PI 2124

PRODUCT INFORMATION

MODIFICATION OF CYLINDER LINERS FOR SCANIA DC09/DC13

Fig. 1: Old version
Item no. 89 911 110

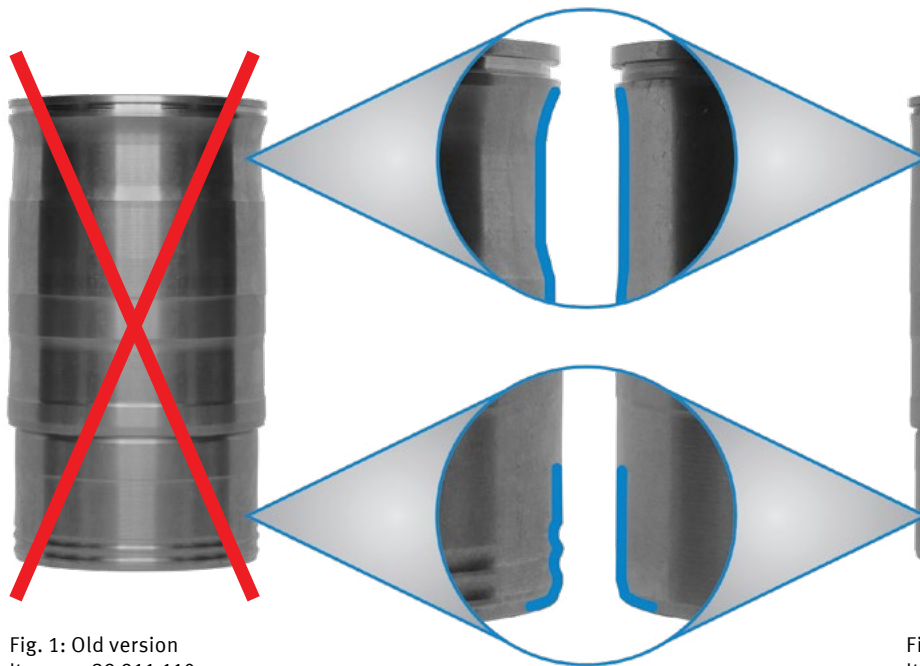
The cylinder liners (item no. 89 911 110) have been revised. The outer contour has been adjusted in two places on the new variant (item no. 89 939 110). These improvements reduce the occurrence of cavitation and thereby increase the durability of the cylinder liners. The functional dimensions remain the same and the old version can still be used.
